**Re: Submission of Baffinland Responses to Intervener Information Requests in relation to the Type A Water License Amendment for the Phase 2 Development Proposal**

## Water License IR Responses Phase 2 Proposal – Mary River Project

Baffinland Iron Mines Corporation  
Mary River Project  
NIRB File No. 08MN053

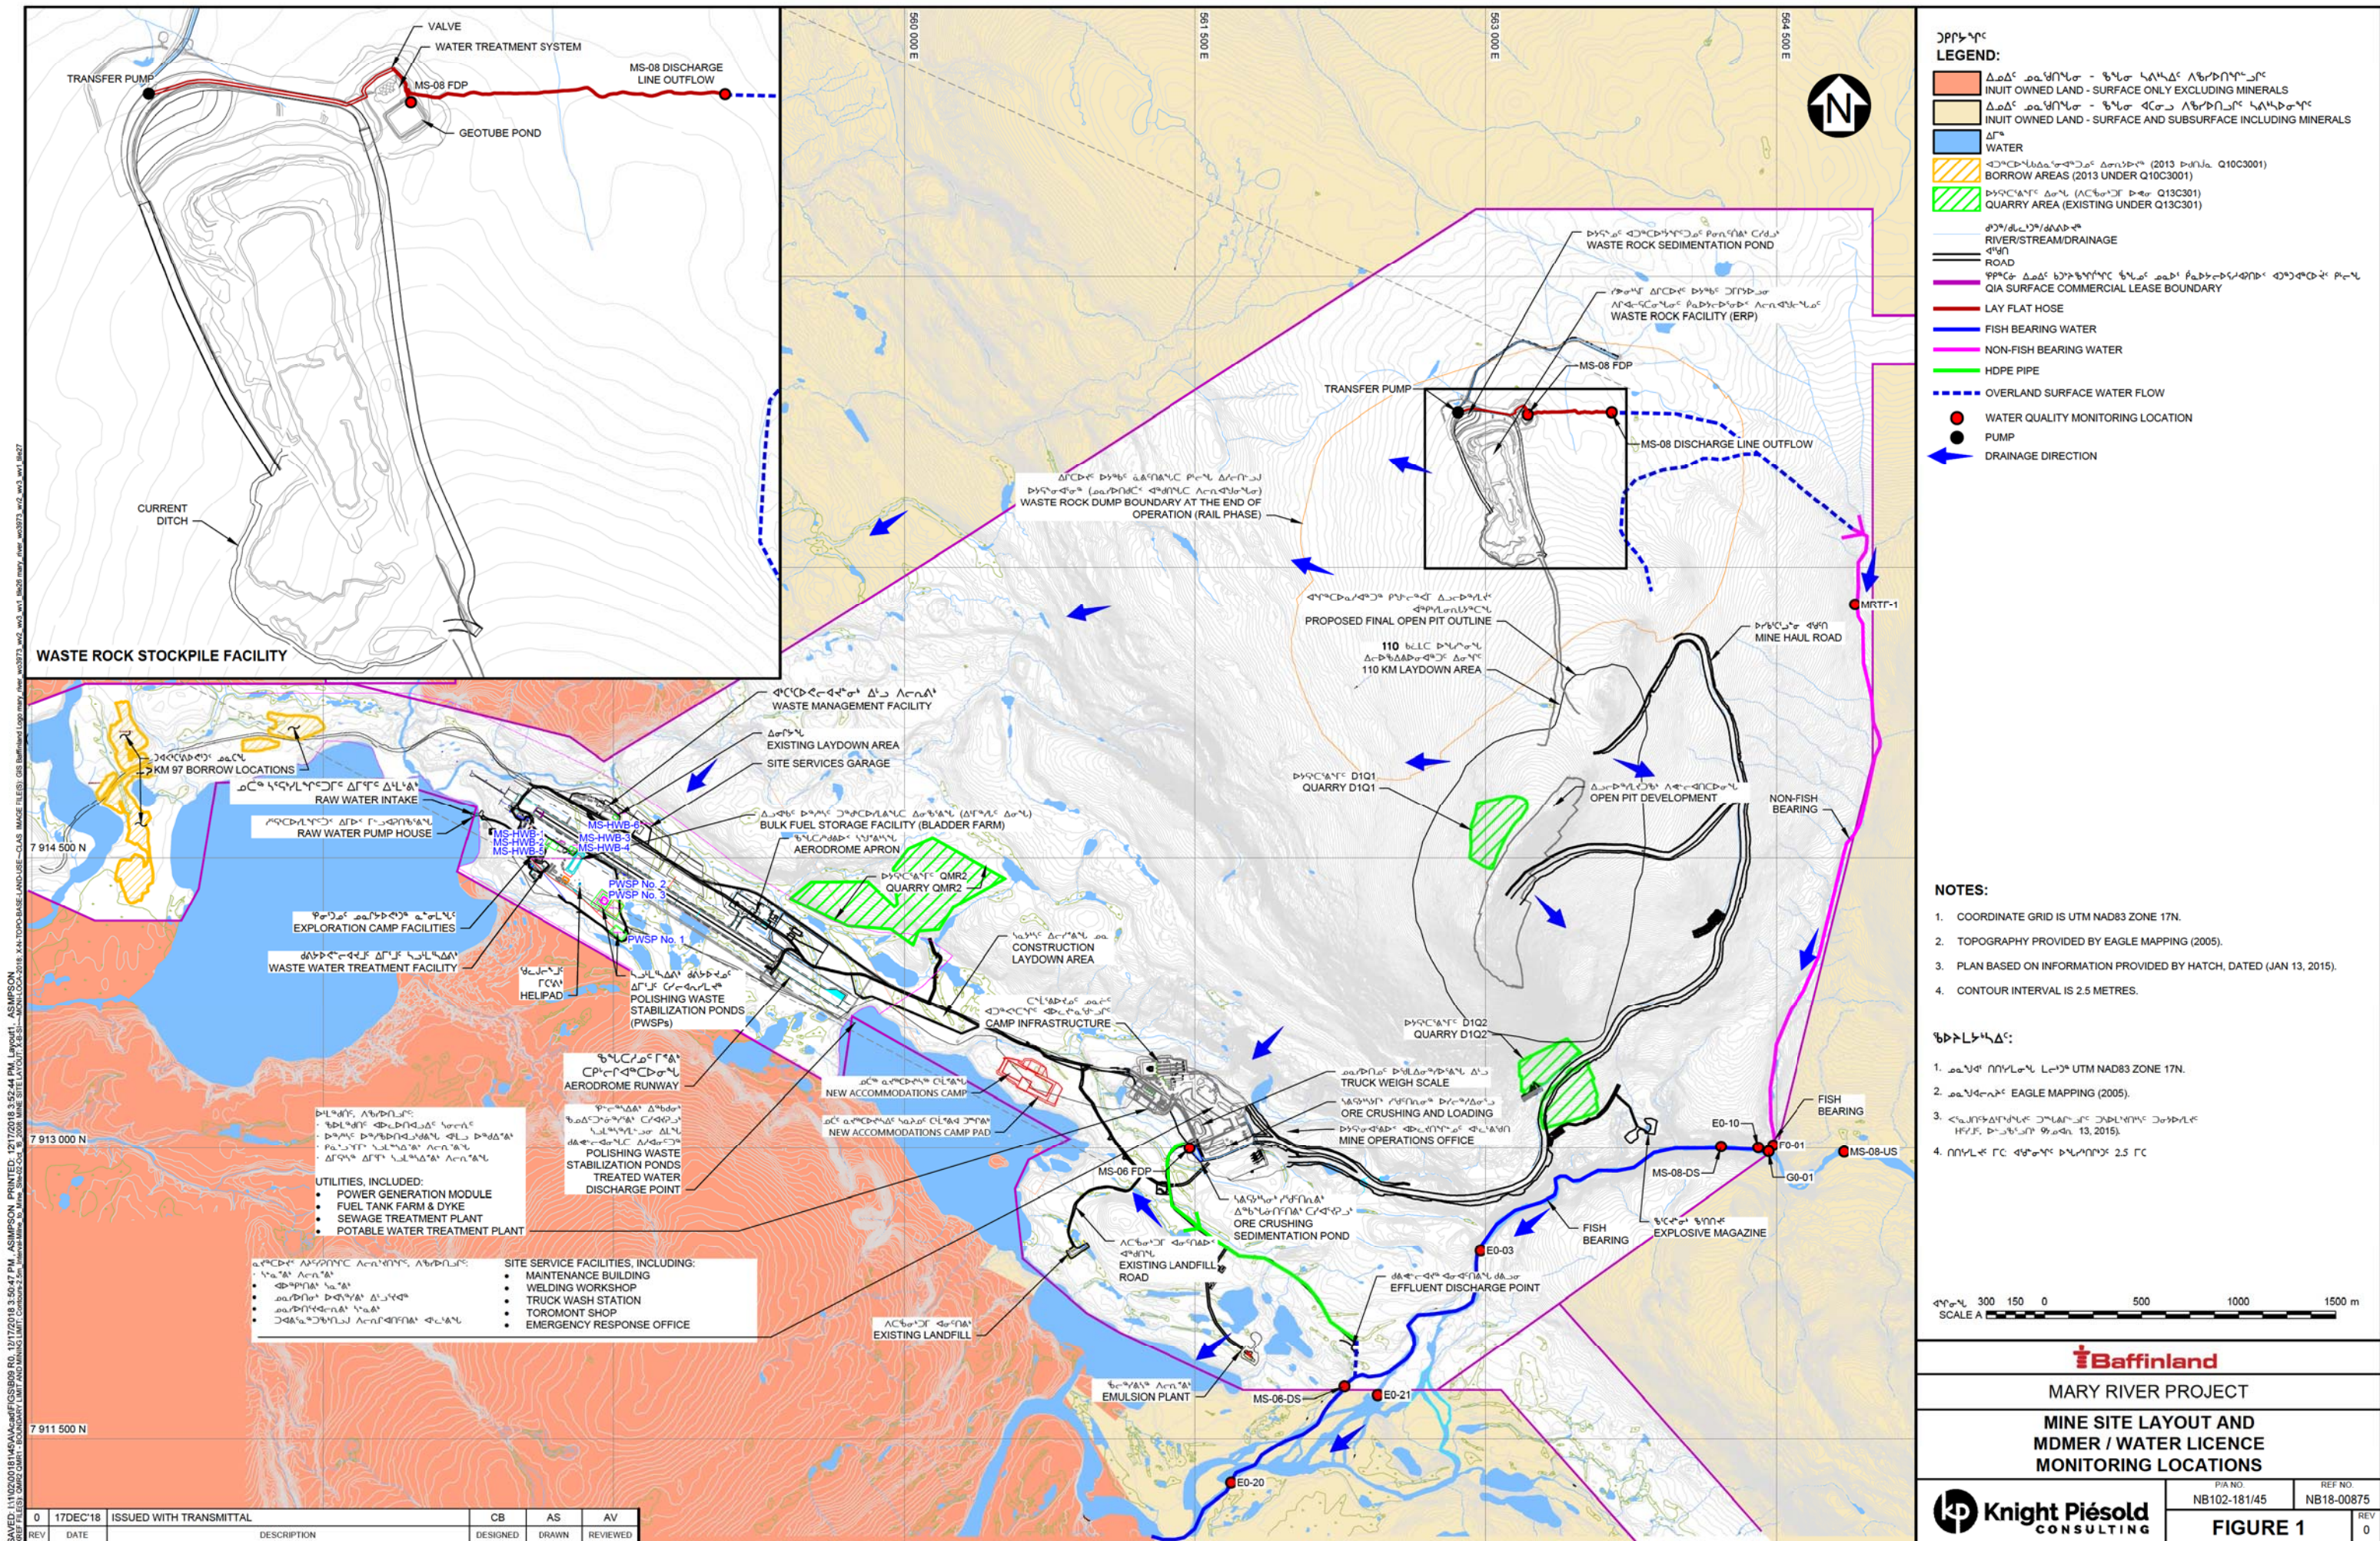
CIRNAC 12	CIRNAC requests that the Proponent provide the following: a) Details on contaminated snow and ice collected volumes from previous and current operations at site; and b) Details on projected volumes and requirements.	a) Volumes of hydrocarbon contaminated snow and ice are presented in the QIA/NWB Annual Report for Operations which can be found on the NWB's ftp site.

ID	Info Request	Response	Attachment
		b) Projections of additional contaminated quantities of snow requiring storage due to the Phase 2 Project are difficult to quantify objectively as the majority of contaminated snow is sourced from unplanned spills/releases of hazardous substances. If additional contaminated snow storage locations are required, they will be identified and developed in accordance with Baffinland's Type A Water Licence. Baffinland already plans to increase its hazardous material containment capacity in 2019 through the construction of lined containment berms that have been included in the 2019 Work Plan as part of the approved project.	
CIRNAC 13	CIRNAC requests that the Proponent provide the following: a) A summary of the investigation reports mentioned above describing the geological conditions and geotechnical investigations along the Railway alignment; and b) A summary of the feasibility study mentioned above regarding the North Railway embankment designs (Hatch 2017c).	The referenced geotechnical reports are presented as appendices to the Application to Amend the Type A Water Licence (TSD 2 Project Description, Appendix D). Geotechnical reports are presented as Attachments 6.1, 6.2, 6.3, and 12.1 to 12.4. The Project Description (TSD 2) provides a summary level of the feasibility study; the feasibility study is not a public document.

Baffinland			
BAFFINLAND IRON MINES LP			
MARY RIVER EXPANSION PROJECT			
RAIL SITE (56km)			
RAIL TEMPORARY LOADING FACILITY			
SCALE	DWG. No.	REV	
1:2000	H353004-30000-224-271-0029-0001		
OR AS NOTED			
SHEET SIZE: A0

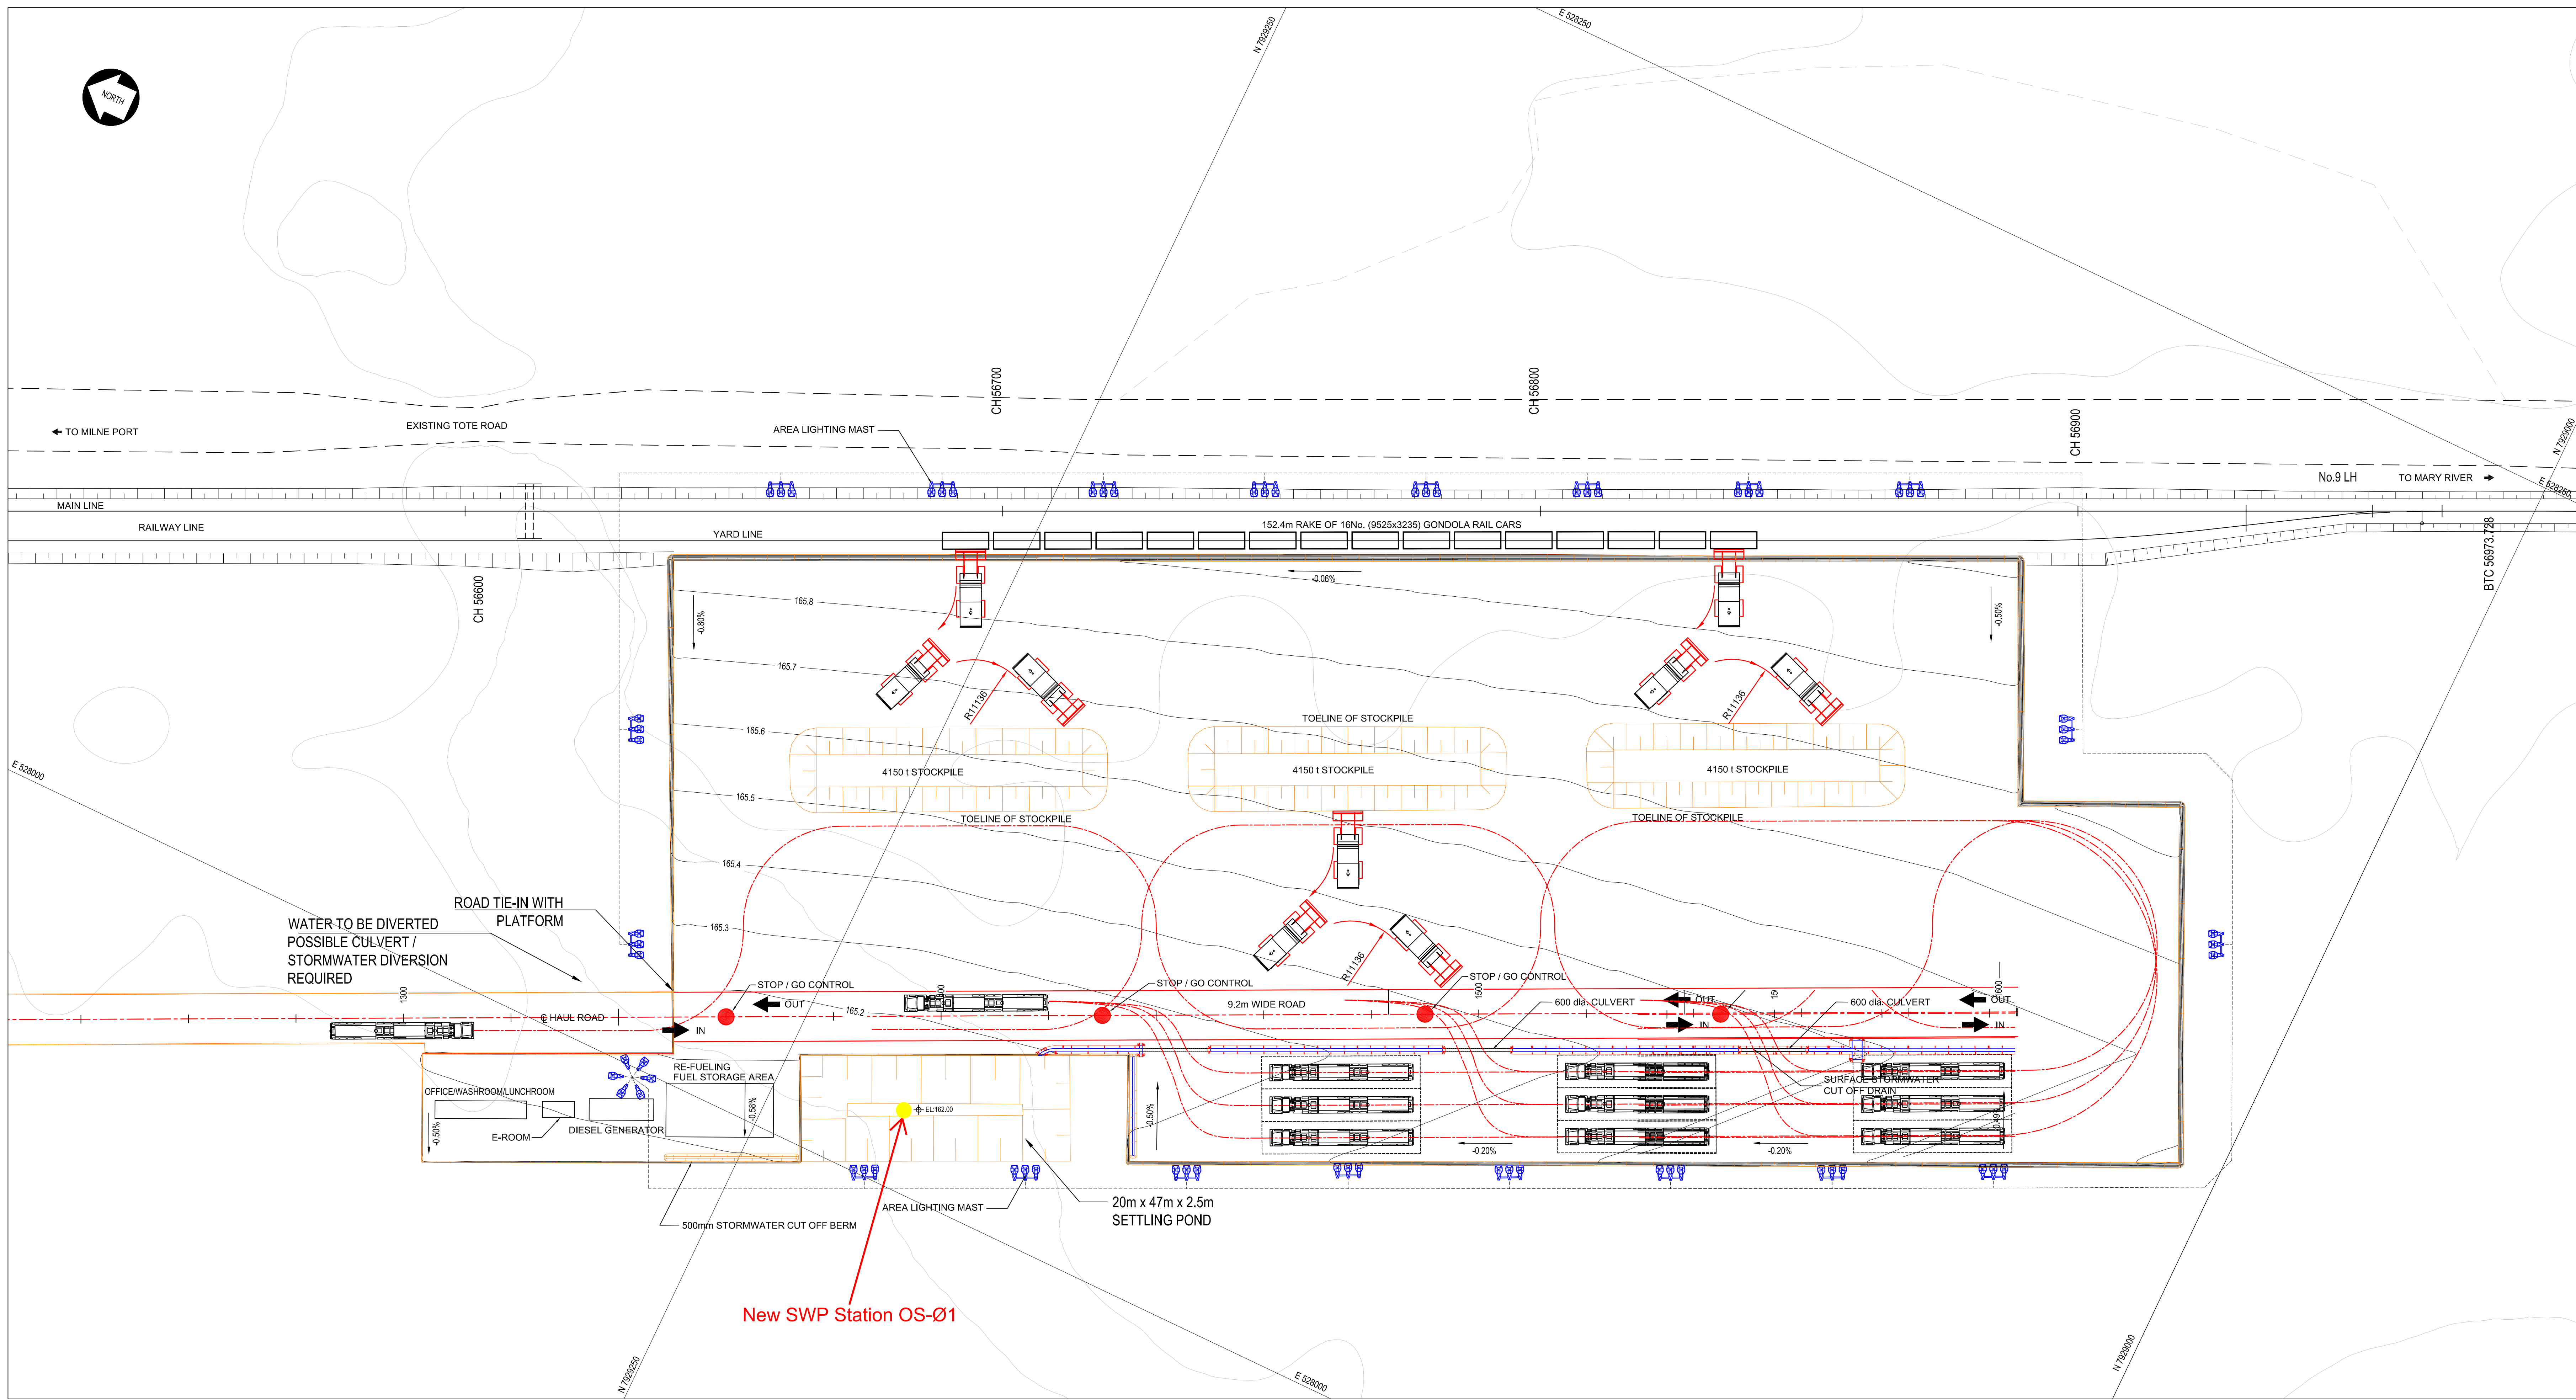
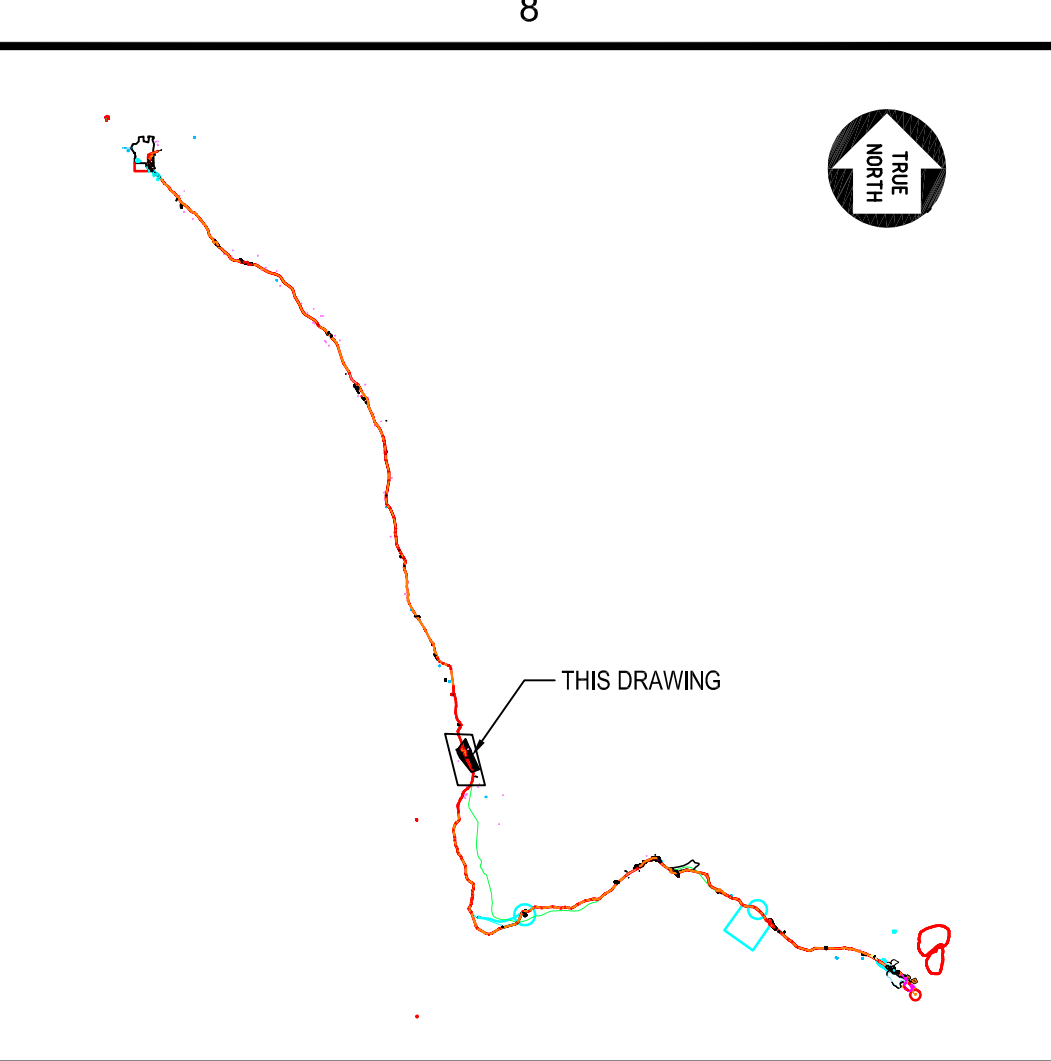
*CIRNAC 06 ATTACHMENT 1: FIGURE 1 – MILNE  
PORT LAYOUT, DRAWING – RAIL SITE, RAIL  
TEMPORARY LOADING FACILITY AND TABLE 6.1 -  
PROPOSED ADDITIONAL MONITORING STATIONS*
